# Draft TECHNICAL MEMORANDUM

**Date:** October 22, 2015

**Subject:** Planting Revisions and Substitutions for the Second Year of Construction and Planting (Phase 2) at the Upper Clear Creek Mitigation Site

FIGURE 1 PHASE 2 - 2015 PLANTING ZONE REVISIONS  
10.22.15

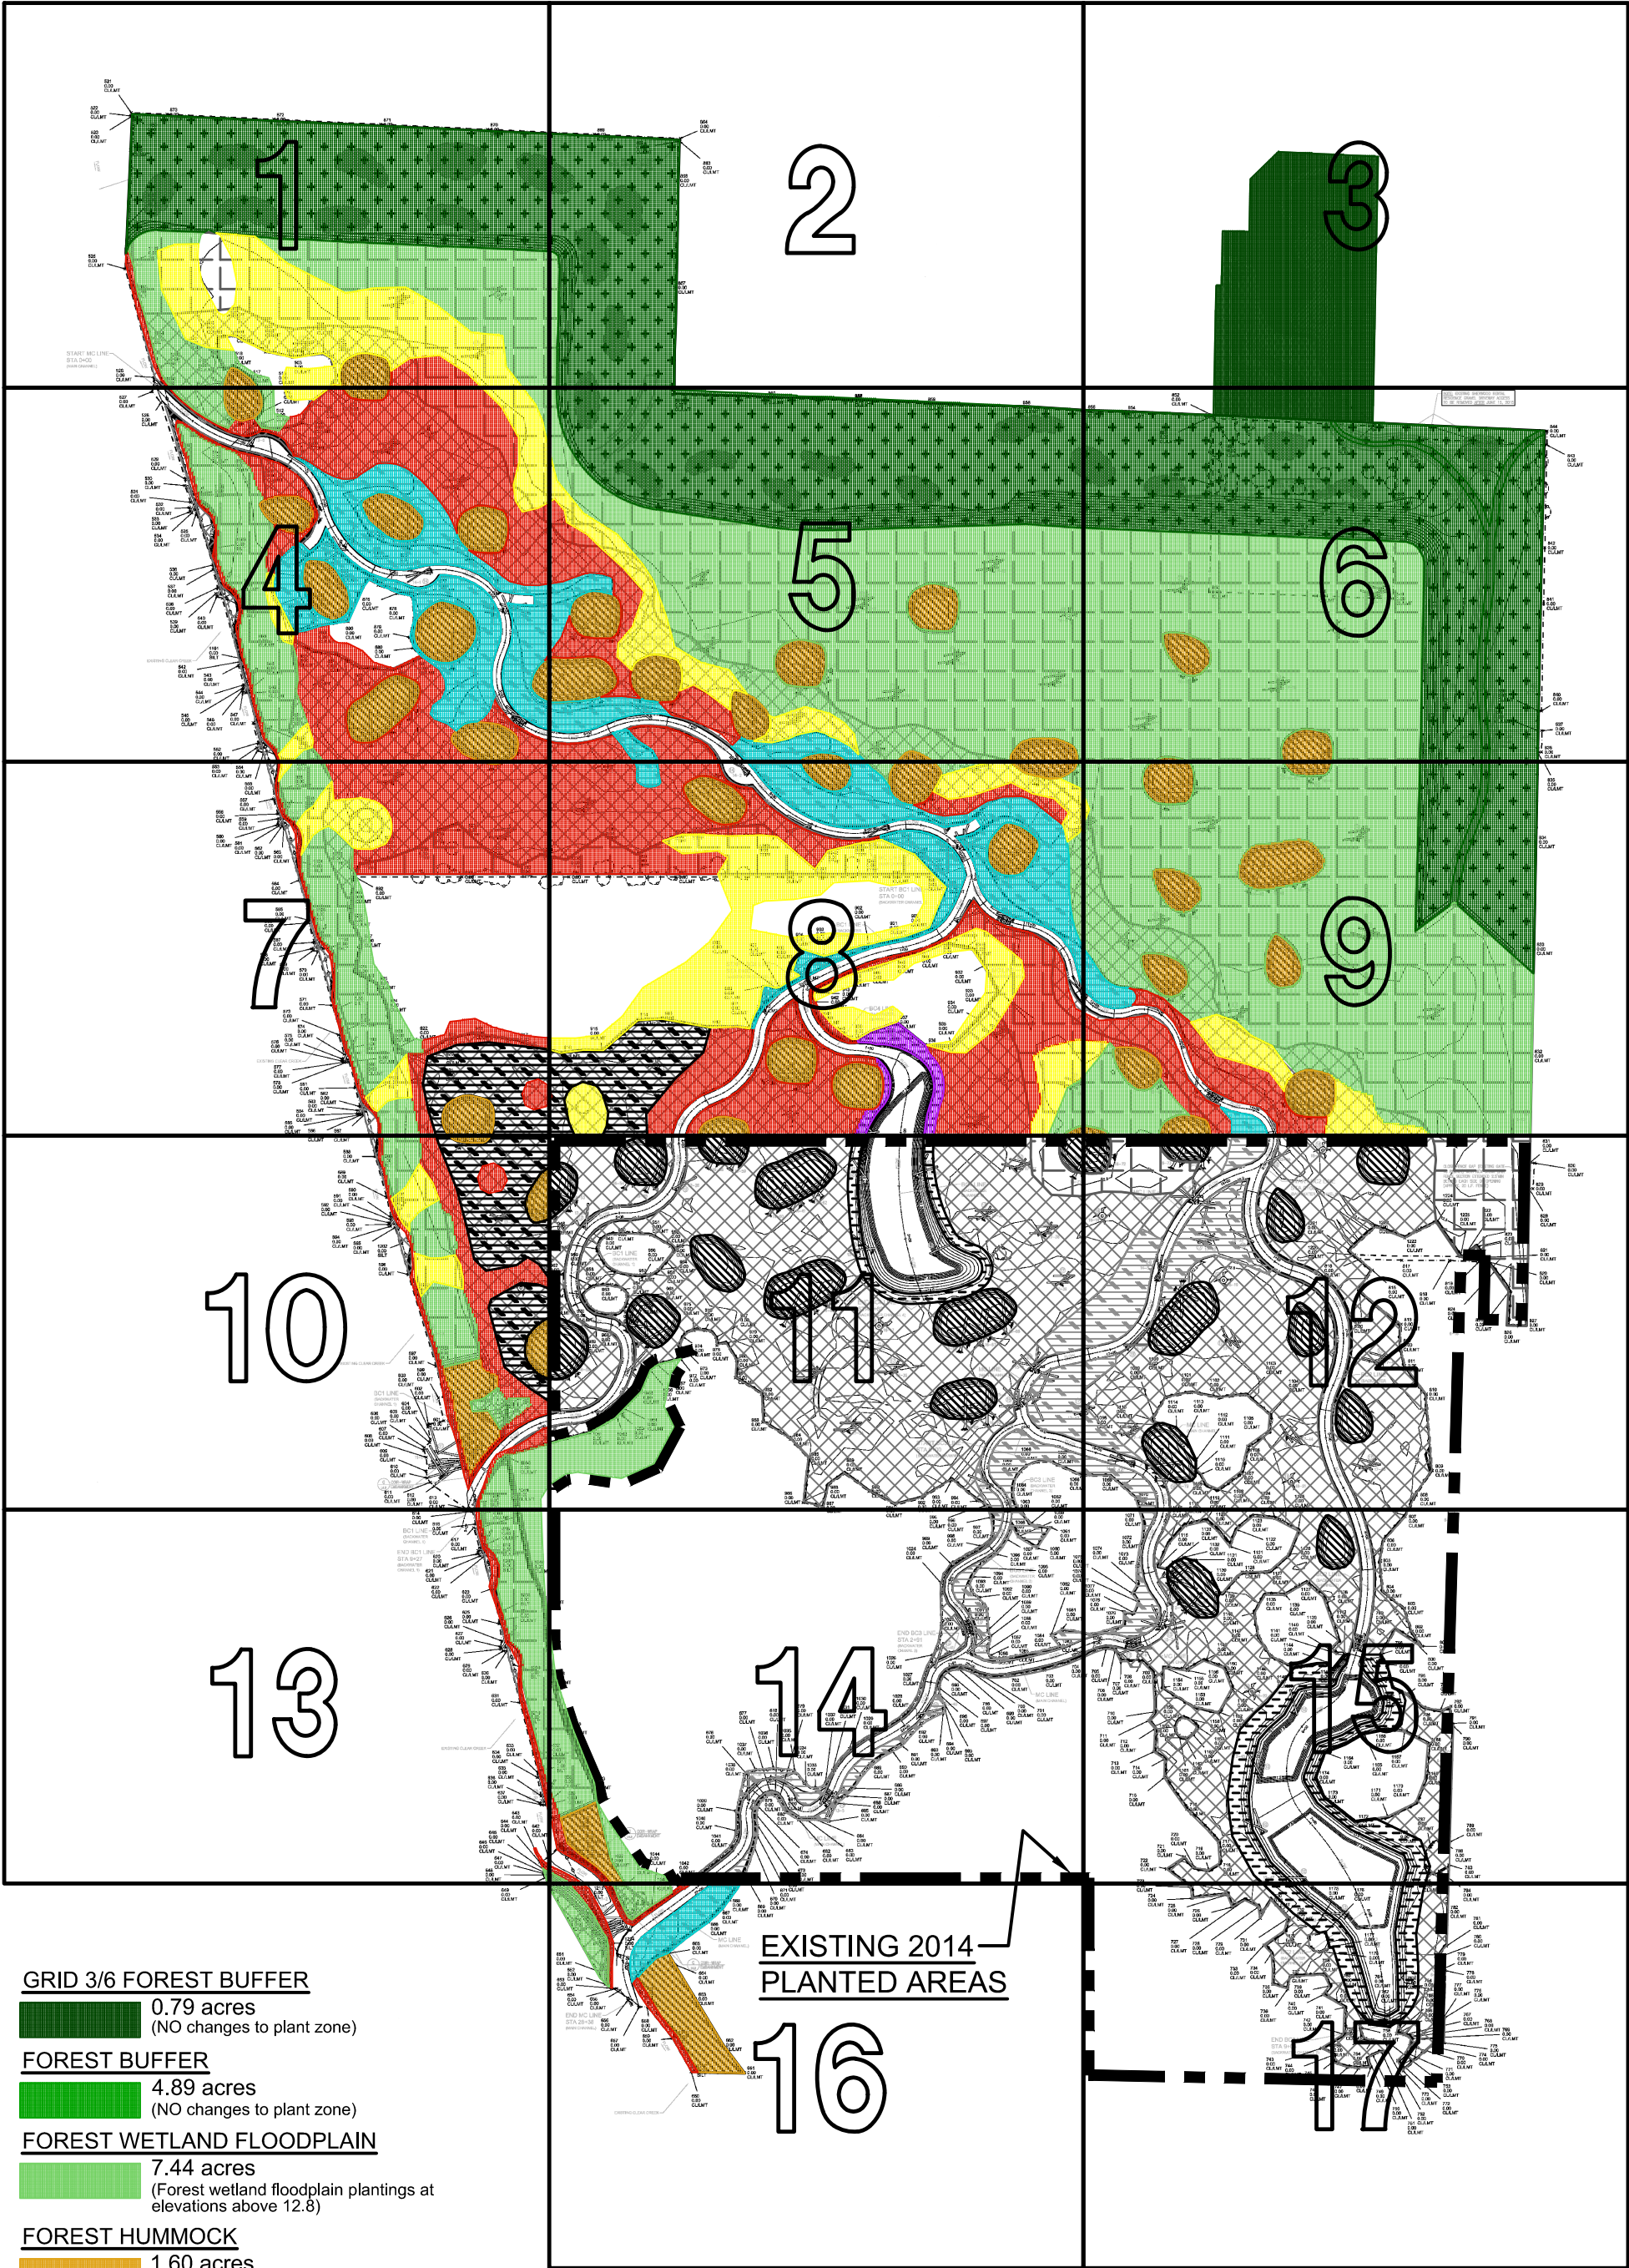
This memorandum presents revisions proposed by the Port of Tacoma (Port) to the planting plan for the second year of construction and planting (i.e., Phase 2) at the Upper Clear Creek Mitigation Site (UCCMS). Phase 2 plant zones are shown on Figure 1. Revisions include plant species substitutions due to unavailability, adjustments to boundaries of retained native emergent vegetation, a new emergent wetland floodplain plant zone area, and expansion of planting zones into additional site improvement areas and areas of additional reed canarygrass control within the UCCMS property limits. In accordance with the Basis of Design report (BDA et al. 2013), the Phase 2 planting revisions described in this memorandum include adaptive management measures to address post-construction hydrologic conditions. In addition, revisions include an option for plant species substitutions applicable to replacing plants that died since completion of the first year of construction and planting (i.e., Phase 1). Upon review and approval by the EPA, environmental permitting agencies, and the Port's Umbrella Mitigation Bank Co-Chairs and Interagency Review Team, these proposed revisions will be implemented to finish construction and will be documented in the as-built report.

Plant zone adjustments for Phase 2 are summarized below. Figure 1 presents the revised boundaries and locations of Phase 2 plant zones and Table 1 presents the corresponding plant schedule. Figure 2 presents adjusted Phase 2 plant zones in relation to SBF WSEs. Within all of the revised plant zones, plants will be spaced according to originally proposed on-center spacing (12 feet for trees; 5 feet for shrubs; 1.5 or 2.5 feet for groundcover; and 1.5 feet for emergent). As originally proposed, where live stakes are planned, they will be installed as pairs at each on-center planting location.

- Forest Wetland Floodplain: Originally specified plant species are proposed and will be evenly distributed. However, to support survival and establishment of plants with less tolerance to inundation, the low ground elevation limit of planting will be adjusted to approximately 12.8 feet, thereby minimizing the potential for sustained temporary inundation associated with the modified upper limit of SBF WSE.

- Scrub-Shrub Wetland Floodplain: Two distinct plant subzones within the Scrub-Shrub Wetland Floodplain zone will be designated at different ground elevation ranges corresponding to potential SBF WSE. Originally specified plant species are proposed, but they will be redistributed to each subzone based on relative inundation tolerance.

- Scrub-Shrub Wetland Floodplain -- Frequently Flooded Zone: Only live stakes will be installed, consisting of originally specified willow plant species on low-lying areas between 11.5 and 12.5 feet elevation. At these elevations, willow plant species are more tolerant of frequent and longer periods of sustained temporary inundation (i.e., up to two months). Live stakes will be installed at a lengths of 48 inches (four feet) instead of the range of 24 inches to 42 inches specified in the Basis of Design report (BDA et al. 2103). The additional length is intended to prevent submersion which can lead to failed establishment or mortality. The live stakes will be installed in the ground at the originally planned two-foot depth, thereby providing at least one foot above the water surface during times of high SBF WSE. Proposed plant species in this subzone include Pacific willow (*Salix lasiandra*), Geyer's willow (*S. geyeriana*), Hooker willow (*S. hookeriana*), and Sitka willow (*S. sitchensis*).

- Scrub-Shrub Wetland Floodplain -- Transition Zone: Only originally specified container-grown plant materials will be installed on relatively higher ground between 12.5 and 12.8 feet elevation. At these elevations, these originally specified plant species are more suited for shorter periods of sustained temporary inundation (i.e., less than one month). Proposed plant species include red twig dogwood (*Cornus sericea*), black twinberry (*Lonicera involucrata*), crabapple (*Malus fusca*), Pacific ninebark (*Physocarpus capitatus*), and peafruit rose (*Rosa pisocarpa*).

In addition to adaptive planting management measures, the Port proposes revisions to the boundaries of retained emergent vegetation, a new emergent wetland floodplain zone, and additional planting associated with expansion of wetland floodplain zones in areas where supplemental reed canarygrass control measures were implemented during construction. These revisions are summarized below and presented in Figure 1.

- During site clearing activities, two areas of existing native emergent vegetation (Grids 1 and 4) that were proposed for retention in the EPA Settlement Area were reduced in size by 0.08 acre to remove additional reed canarygrass around the edges. Scrub-Shrub and Forested Wetland Floodplain plant zones will be expanded into the areas where additional reed canarygrass was removed.

- During site clearing activities, an additional 0.05-acre area of existing native emergent vegetation was discovered in the EPA Settlement Area (Grid 1) that was retained. This area contributes to offsetting the reduction of retained emergent area indicated above and further supports habitat interspersions.

- The Port proposes a new emergent wetland floodplain zone in the Port Umbrella Mitigation Bank Area (Grids 7, 8, and 10). This zone was seeded with the wetland seed mix during the fall of 2014 and was originally planned for planting in Phase 2 as part of a Scrub-Shrub Wetland Floodplain plant zone. Since it was seeded, this zone has established into a dense and diverse emergent plant community colonized by native species from the seed mix and others that established from the existing seed bank (i.e., volunteers). The Port proposes to maintain this new emergent zone with the objective of increasing plant community diversity on the UCCMS. Small patches of Scrub-Shrub Wetland Floodplain zones are proposed within this emergent zone to increase habitat interspersions.

- An additional 25-square-foot area of live stake planting is proposed on the west bank of the pre-construction Clear Creek channel directly downstream of the deflector structure that diverts flow into the new main channel near the upstream limits of the UCCMS (Grid 13). This additional planting is intended to prevent potential bank erosion during high flows by increasing soil cohesion.
